Re: Comments and Contested Case Hearing Request Regarding Clancy
Utility Holdings LLC proposed Texas Land Application Permit (TLAP)
No. WQ0016335001

Clancy Utility Holdings LLC, 4143 Maple Avenue, Suite 400, Dallas, Texas
75219, has applied to the Texas Commission on Environmental Quality
(TCEQ) for a new permit, Proposed TCEQ Permit No. WQ0016335001, to
authorize the disposal of treated domestic wastewater at a daily average
flow not to exceed 39,000 gallons per day via public access subsurface
area drip dispersal system with a minimum area of 16.20 acres.

Fig. 1: The proposed location of the Mirasol Springs wastewater treatment plant and effluent land application areas (red circle) are shown in relation to numerous area wells (purple circles).

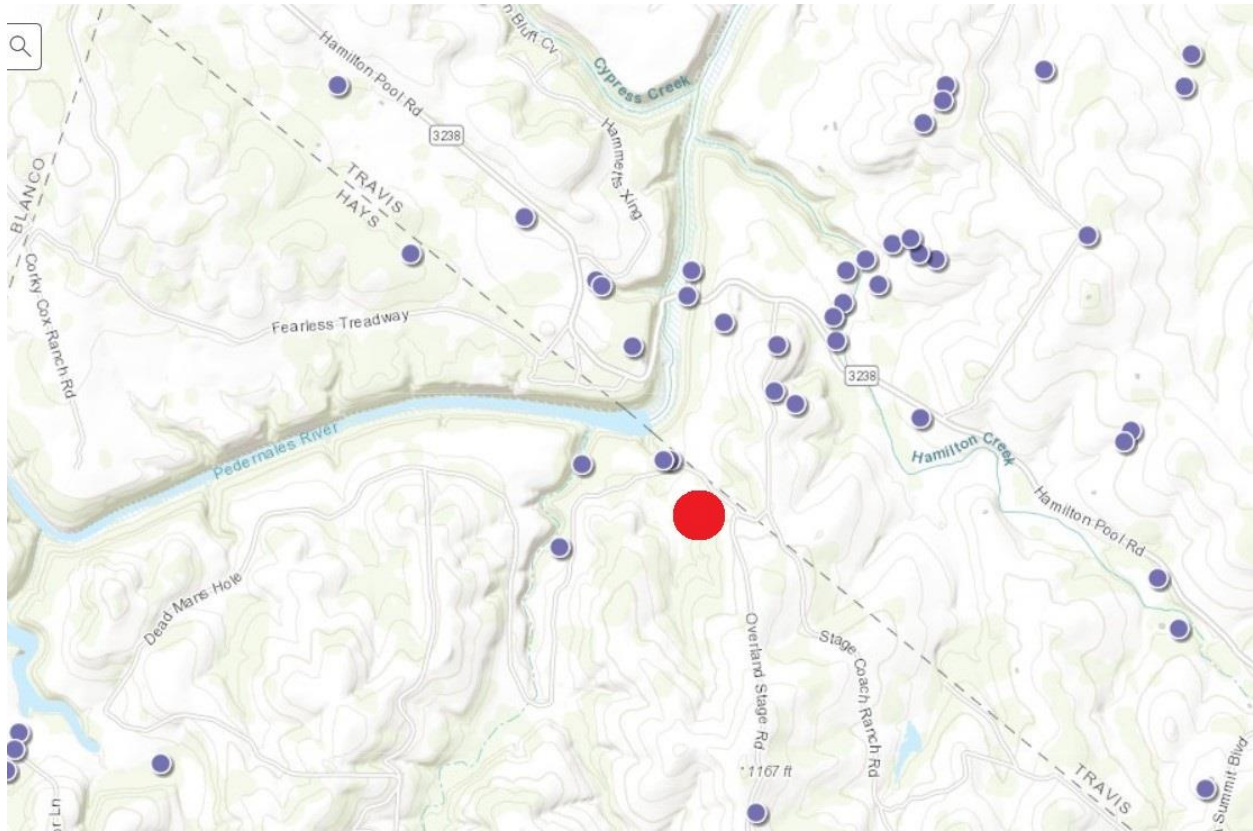
Austin, and Lady Bird Lake). We also have serious concerns regarding potential contamination of area water wells that will likely occur with the irrigation of treated sewage and wastewater/stormwater runoff at the proposed site (Fig. 1). We therefore recommend that the Clancy Utility Holdings wastewater permit be modified or denied, for the reasons presented in these comments.

The treatment disposal facility is located in an environmentally-sensitive area that is home to several species classified as endangered or potentially endangered under the federal Endangered Species Act. The treatment and disposal facility are also near and uphill of several sensitive springs and in an area with thin soils that are unsuitable for a subsurface area drip dispersal system.

Fig. 2: The Mirasol Springs effluent drip fields would sit between areas of higher elevation (red) and the lower elevation Pedernales River (blue), creating problematic stormwater/wastewater runoff into the river during rain events

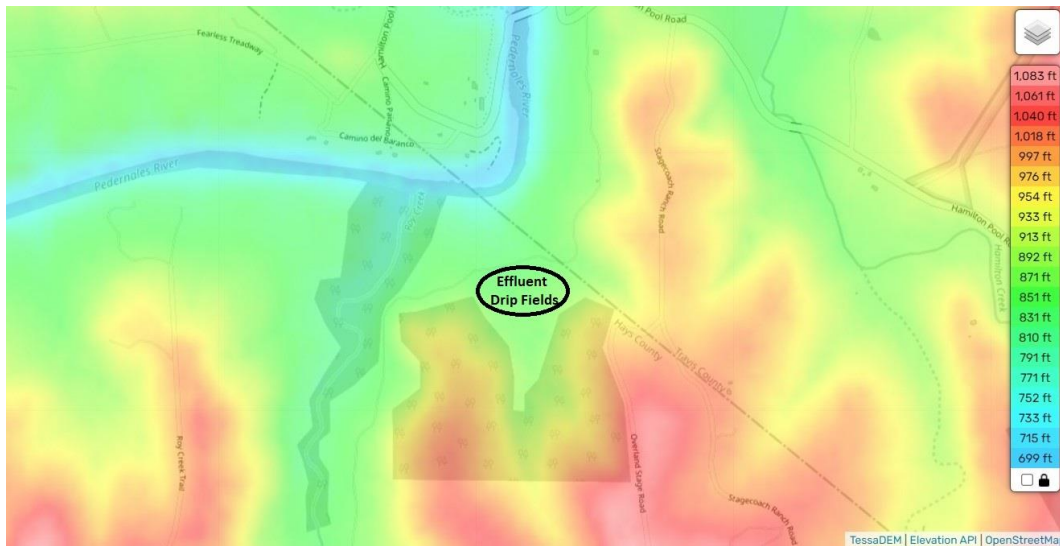
The topography and layout of Mirasol Springs are problematic for any development that uses a wastewater treatment plant and irrigates treated sewage over land, as Mirasol Springs would under the current plan. Aside from the fact that there's no reliable year-round water supply in this area for such a development, the topography itself consists of steep hills sloping down towards the Pedernales River, thereby assuring rapid overland flow of stormwater (and land-applied wastewater) during rain events (Fig. 2 and Fig. 3).

Fig. 4: A small drainage ditch, shown in red, bisects the proposed effluent drip fields (shown in dark orange) and provides a direct flow path from these fields to the lower-elevation Pedernales River.

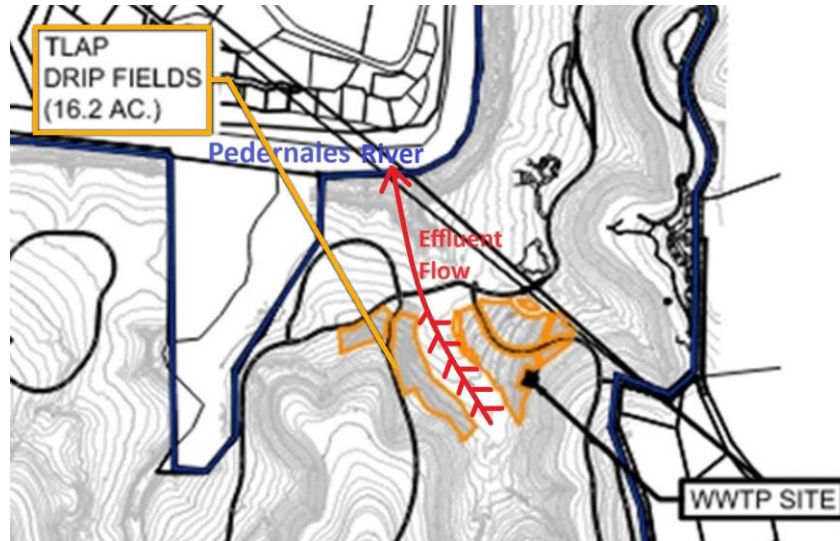
The proposed effluent drip fields are located between steep surrounding hills and the Pedernales River, with a small drainage ditch bisecting these effluent fields. This small drainage ditch would collect combined stormwater/effluent runoff during rain events and deposit this runoff into the Pedernales River (Fig. 4).
